Northville DDA Economic Development Committee

DRAFT
**Planned Unit Development (PUD)
Eligibility Review
For
City of Northville, Michigan**

Project Name: The Downs Planned Unit Development (PUD)

Plan Date: August 13, 2018

Figure 2 – City of Northville Sub Area Plan Update: Racetrack

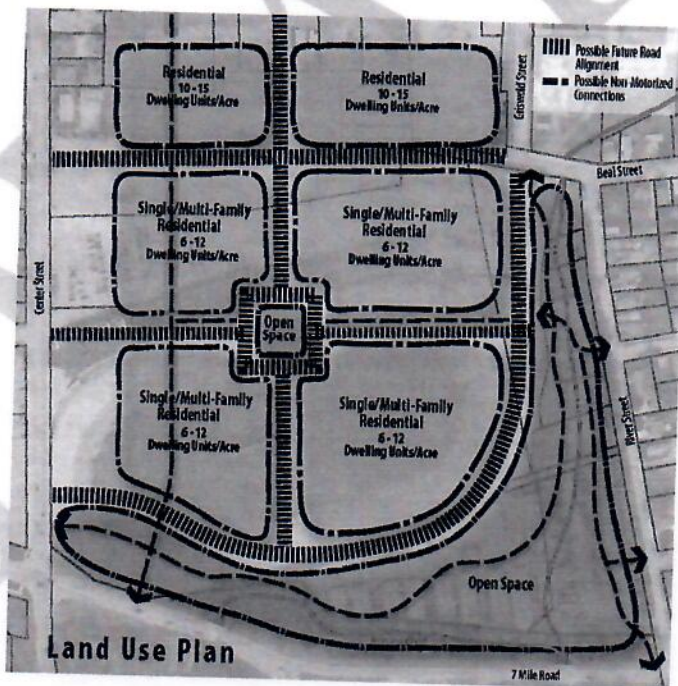
The proposed park is a positive aspect of this plan. We would recommend that the following modifications be considered to create a park that is consistent with the Master Plan:

1. **Daylight the river.** This is a significant goal in the City's Master Plan. In our opinion, it would be very unlikely that the river could ever be daylighted in the future if the proposed number of home sites and townhomes abutting the park are constructed. We

As summarized in your draft review letter and outlined in the City's Master Plan, "If feasible, the Middle Rouge River should be exposed and a greenway or riverfront pathway should be developed as a linear park." The Developer has retained numerous experts to study the potential to "expose or daylight" the river including civil engineering firms, wetland and environmental consultants, and earthwork contractors. A feasibility study was conducted and it was determined that the cost to "daylight" the river would be in excess of \$3,000,000. (Cost study has been attached as Exhibit A) Based on this cost, it is determined that it is not feasible to daylight the river without a public grant.

Figure 3 – Subject Sites Showing Master Plan Sub Areas

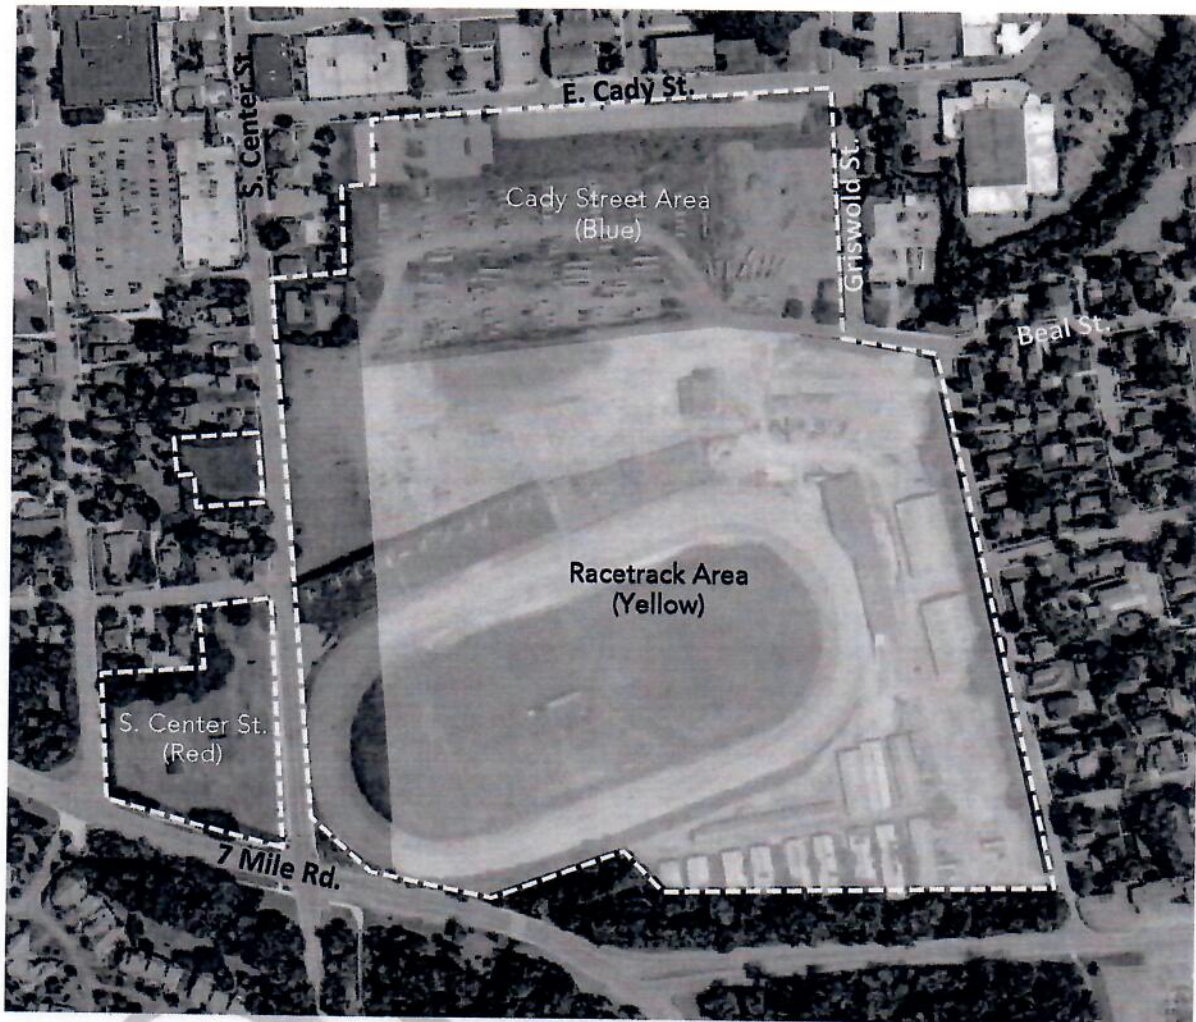
CWA Comments: For clarity, we have divided the project into three areas according to the Sub Areas found in the Master Plan: Cady Street (in blue), the Racetrack property (in yellow), and the S. Center Street area (in red). An illustration of the three areas is shown on the next page:

- The Master Plan shows “transitional/mixed-use commercial/residential” along Cady St. The project proposal indicates two small buildings with commercial on the first floor and one large apartment building with no commercial uses. While this configuration is mixed-use, only 18,700 square feet or 6% of the total floor space is dedicated to commercial uses. A balance needs to be created between extending commercial uses to this area without competing with the downtown. As mentioned below, we think the commercial uses along Cady St. could be expanded by adding a small commercial building (similar to the proposed buildings) at the corner of Cady and Griswold.

- The Master Plan calls for reduction in density as you move from Cady Street south. The proposal shows the large apartment building spanning the area between Cady and Beal, with a long and narrow apartment building on the Beal St. side of the parking structure. This configuration doesn’t provide much of a transition between the highest density (apartment building), and the single-family homes on the south side of Beal. We understand that the topography isn’t conducive to building townhomes in this area.

- The Master Plan calls for locating parking behind buildings. The proposal shows a large surface lot at what we consider an important corner of this area (Cady & Griswold), which is contrary to this goal. As mentioned above, this corner could accommodate a small commercial building, with parking behind.
